**Environmental
Planning
Commission**

**Agenda Number: 06
Project #: 2018-001843
Case #: RZ-2020-00048
Hearing Date: February 18, 2021**

Supplemental Staff Report

Request Amendment to the Integrated Development Ordinance (IDO) Text – Small Areas for the 2020 Annual Update

figure 41 view plane and sighting lines

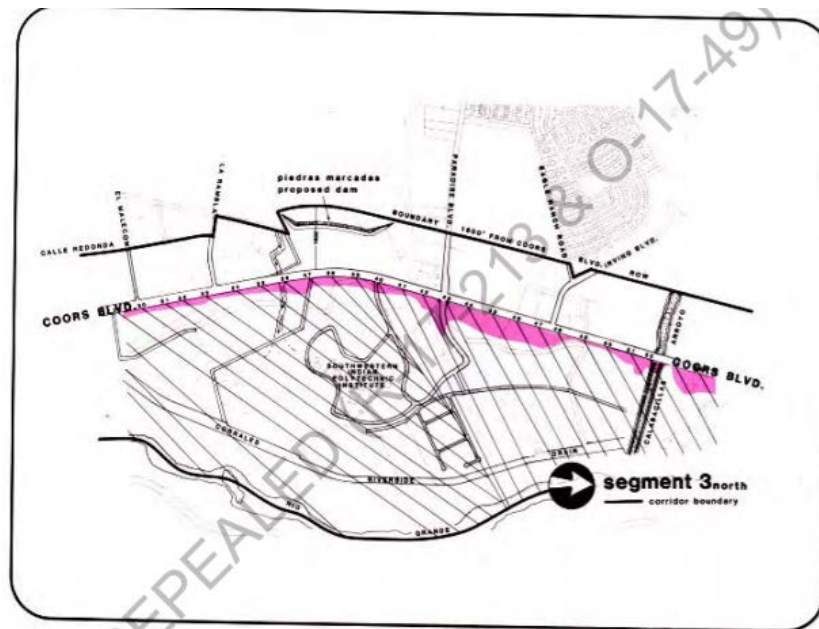
Update: At the January EPC hearing, there was 1 comment in support and 1 comment in opposition to the proposed Coors Boulevard VPO-1 amendments. The opposing commenter stated that the sightlines shouldn't only be at 45° angles because Coors Blvd. curves and that the main view to protect is of the Sandia crest. There were 3 written comments in support of the proposed amendment, 2 from the same commenter. A meeting was held with 2 of the 3 commenters to discuss the proposed amendments. In this meeting, staff reviewed the view preservation regulations and diagrams from the original Coors Boulevard Corridor Plan to identify the prior legislative intent and how the rules were written. There is a diagram in the plan that shows how the sightlines are to be drawn, which is the basis for both of the commenter's concerns.

The written comments made a few points: 1) that moving away from the 45° angle would mean that the sightline may not even cross through a building, impacting our ability to do the building height test, 2) the intent of the plan was to preserve different view perspectives to the mountains as a whole, not just the Sandia crest ridgeline, and 3) if the Sandia crest is included in all view frames, then the application of the bulk and massing and ridgeline tests would be altered and result in substantial differences in what could be approved after this amendment.

Because the requested amendment would substantially change the way that the sightlines are drawn, Planning staff recommends no change to the original proposed amendment.

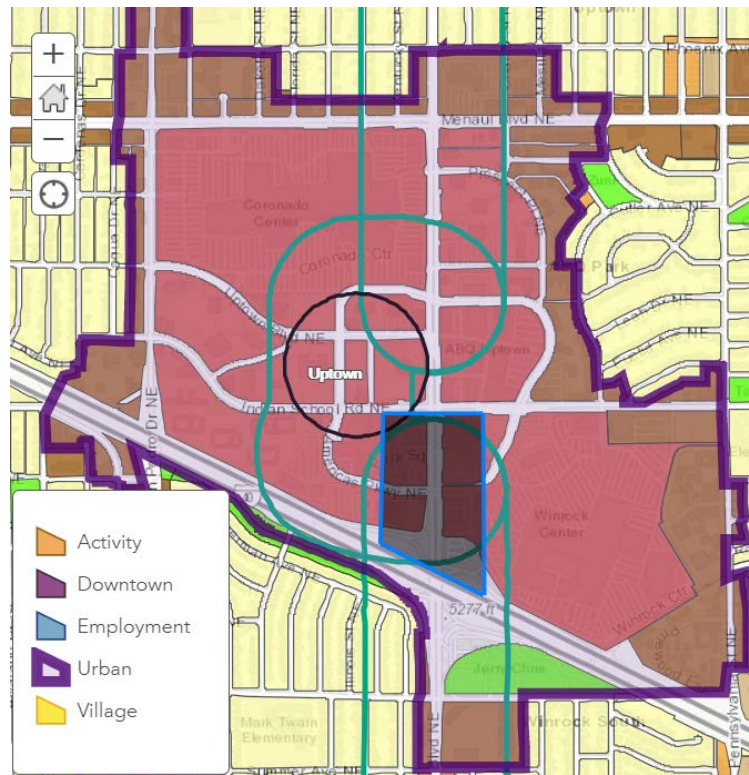
Although the areas in close proximity to I-40 are not walkable due to heavy traffic, adding drive-through uses for 1,320 feet would impact approximately half of the Uptown Urban Center. There are only two urban centers in the City- and the proposed amendment would adversely impact the ability of the Uptown Center to develop a more urban, dense, and pedestrian supportive character.

By their nature, drive-through and drive-up facilities do not promote pedestrian activity, though they can implement some minor improvements (such as colored crosswalks) on the surface to address pedestrian safety issues, they are fundamentally an auto-oriented use and do not belong in the Urban Center and should not encroach into the heart of it. Restaurants in Uptown can still serve customers during the pandemic by providing curbside pickup services; a drive-through is not necessary. Furthermore, there is not likely to be space on the sites of already-built restaurants, so the proposed amendment is more about new development.

Though Planning Staff does not support the proposed amendment, a distance of 660 feet would be more reasonable and would allow the amendment without compromising the main portion of Uptown. Walkability is the most basic mode of transportation and it must be kept in mind that not everyone has a vehicle, especially in the more urban parts of the City. Standards must be kept in place to help address conflicts between pedestrians and vehicles.

Update: There were two comments in support of the proposed amendment, one suggesting to expand it to allow drive throughs in the entire Urban Center. Two other commenters suggested allowing drive throughs through a conditional use approval process. The EPC discussed the potential of narrowing the scope to apply to the area near the I-40 interchange at Louisiana as being the most automobile oriented portion of the center, due to the lack of a frontage road, which would provide more of a nexus than allowing drive throughs along the length of I-40.

Staff recommends a condition of approval to remove this proposed amendment because it is inconsistent with a preponderance of Comp Plan goals and policies, particularly those regarding Centers & Corridors. Staff has prepared alternate conditions to address other options, as discussed here.
